Change Order

PROJECT *(Name and address)*:
East Middle School-Classroom Addition
130 Merlin's Maze
Biscoe, NC 27209

CHANGE ORDER NUMBER: 002
DATE: 08/25/2017
ARCHITECT'S PROJECT NUMBER: 1548
CONTRACT DATE: 04/05/2017
CONTRACT FOR: General Construction

CHANGE ORDER NUMBER: 003
DATE: 08/29/17

C-04

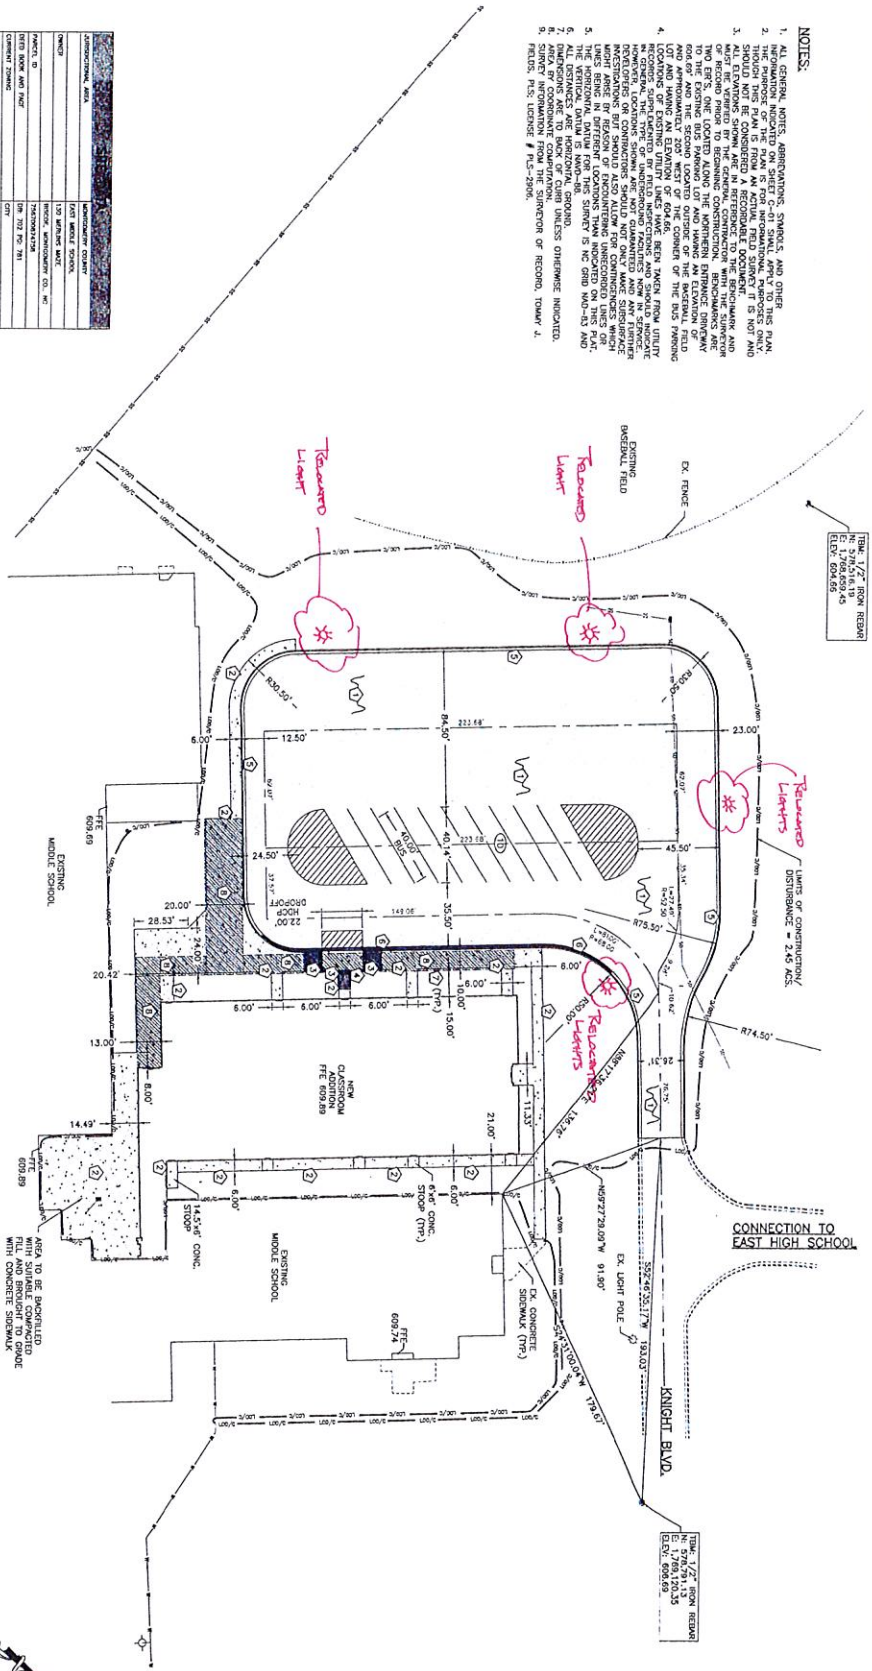
Randy I think there is some confusion on this.
The civil drawing say remove the existing light poles.
Per sheet C-03 Demolition Plan.
Sheet E1.0 note 3 says Remove existing site lighting pole and fixtures.
Turn over to the owner. Demolish pole base.
This work has been completed and Bill's people have already pick these up and moved off site.

Note 4 Sheet E1.0 shows (2) two new pole lights.
It also says to see civil for exact locations.
There is no locations on civil drawings that I can find.
I can use the drawing you sent I just need you to take (1) one of the (3) three lights off.
There is only (2) two pole lights now.

East Middle School
1200 Merlins Maze

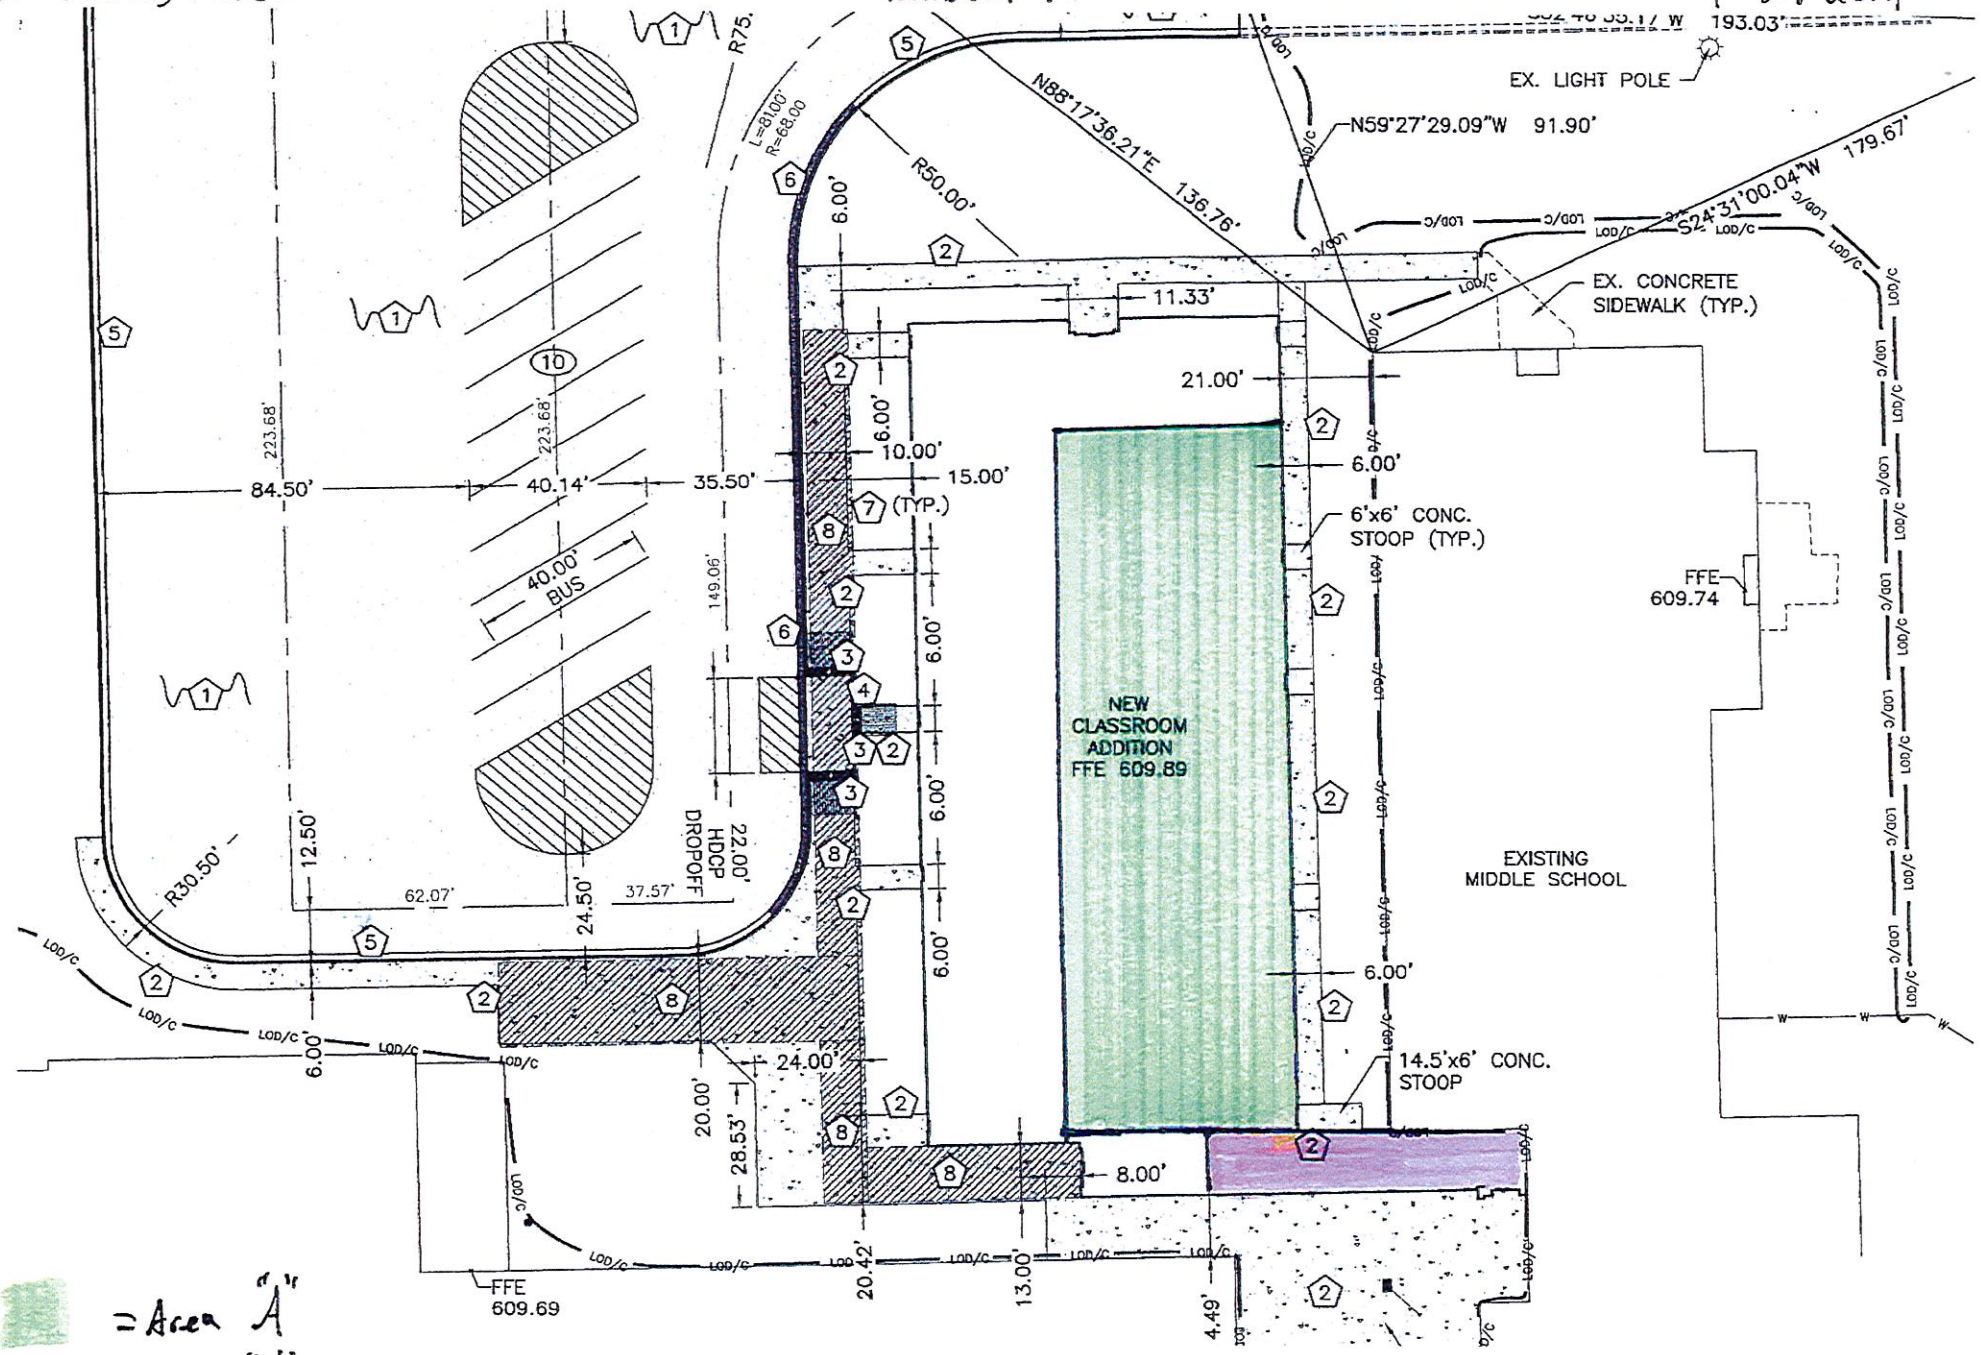
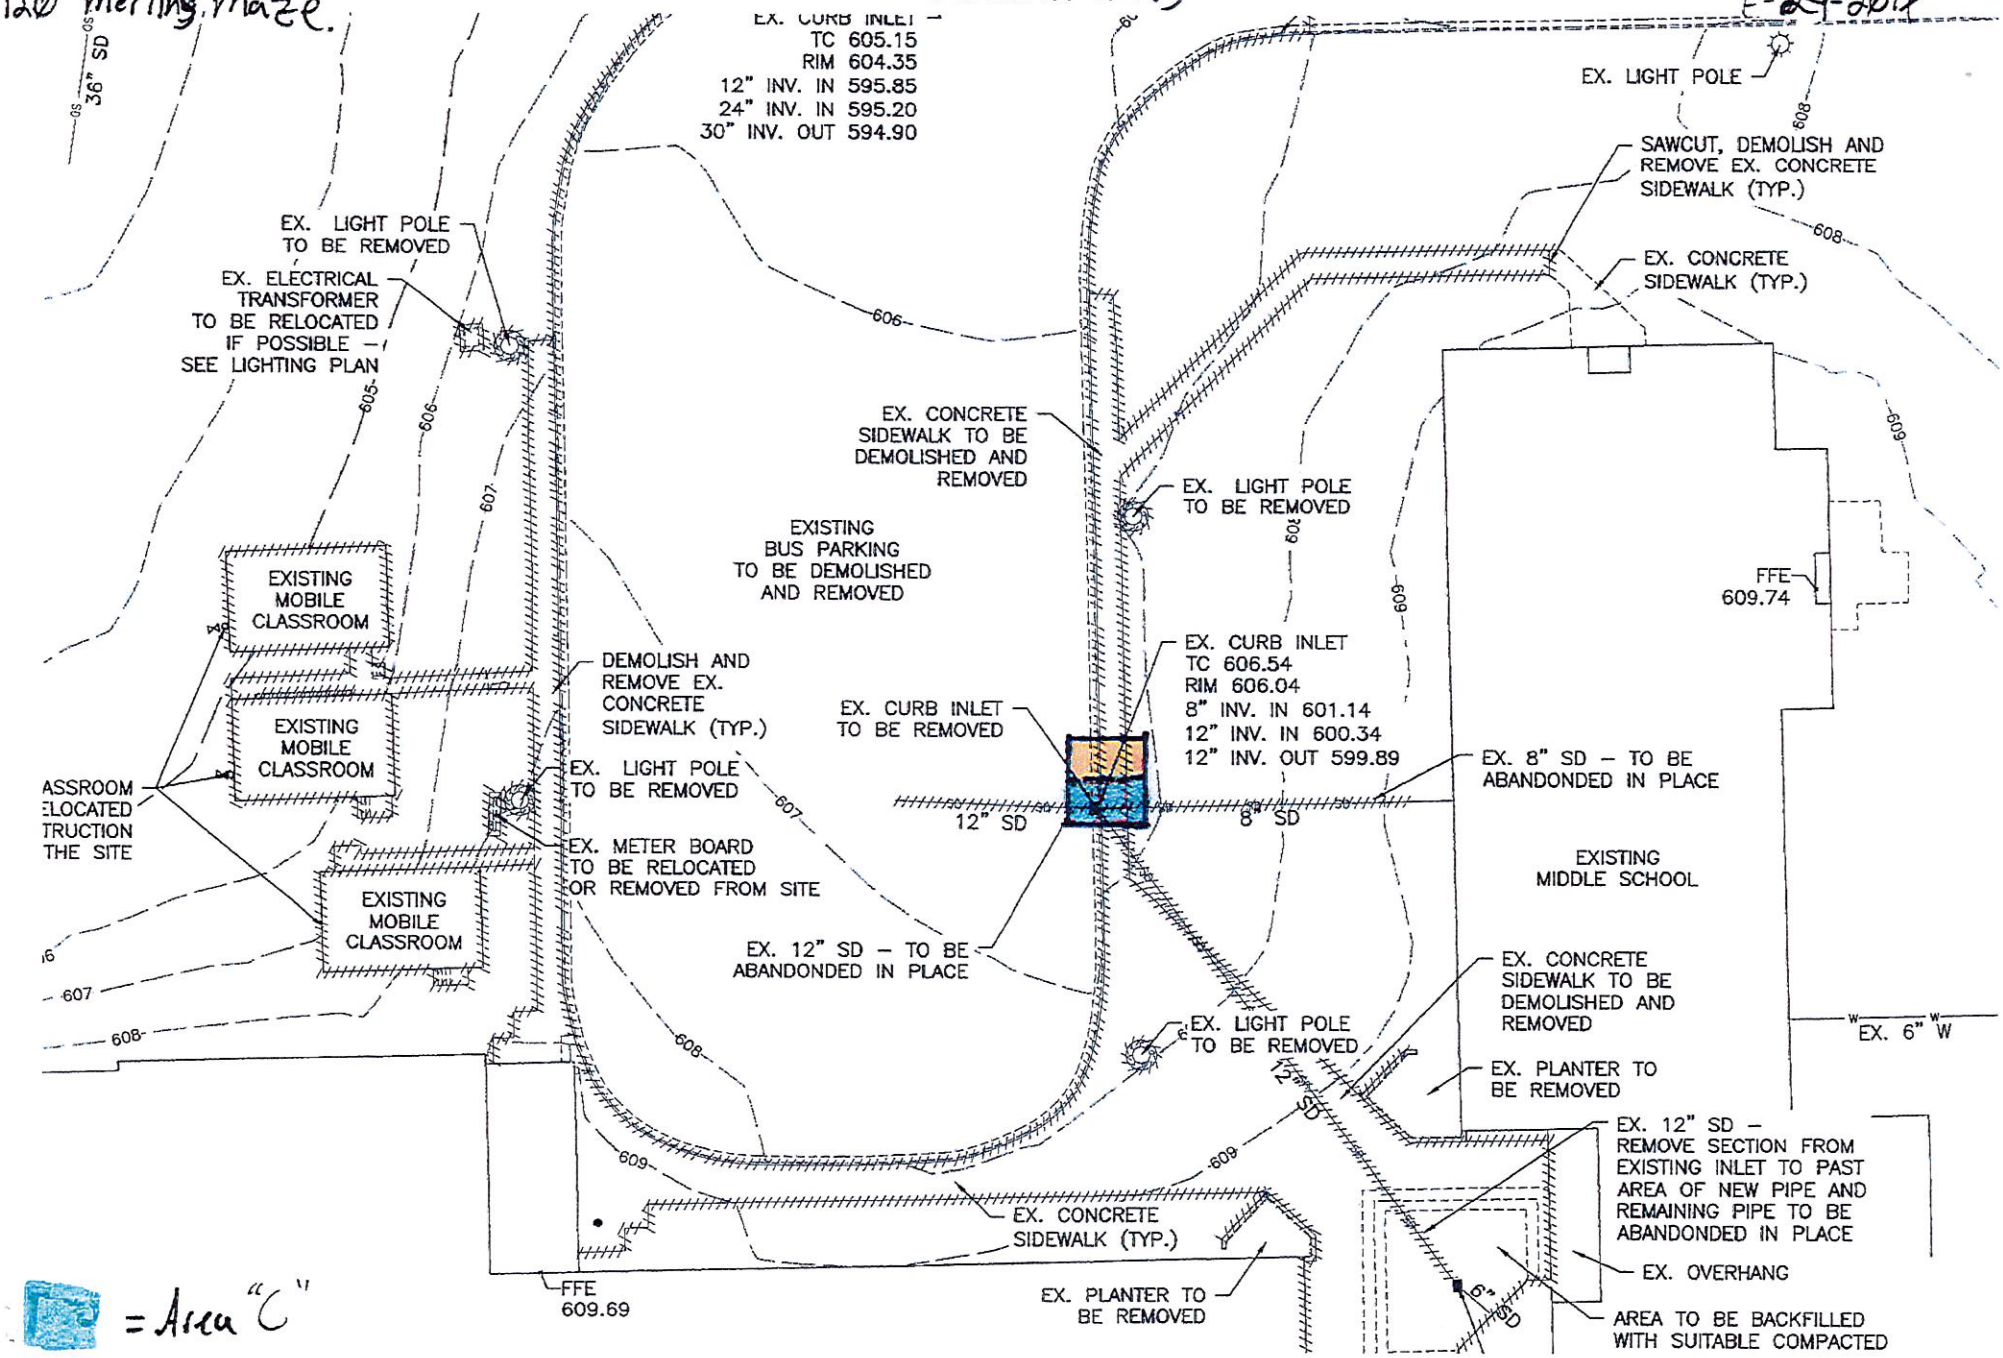
Upon excavation fat clays and silty clays were found. ECS recommendation remove unsuitable fill in building pad to approximately 3''8"" below FFE where applicable. (3' from soil subgrade elevation)

Soils quantifications for building pad area as follows; Area "A" 154' x 54' x 1.25' (average depth) = 462 cubic yards, Area "B" 65' x 15' x 3.5' = 126.38 cubic yards.

Removal of existing curb inlet. Please see the attached sketch for details on the location.

Soils quantifications for removal of existing curb inlet as follows; Area "C" 15' x 13' x 6' = 43.33 cubic yards, Area "D" 1/6 x (16' x 4') x (2 x 14+10') = 15.01 cubic yards. Equation; 1/6 x (b x h) x (2 x a+L) = Volume. NOTE area "D" was a wedged shaped ramp for equipment access and safety.
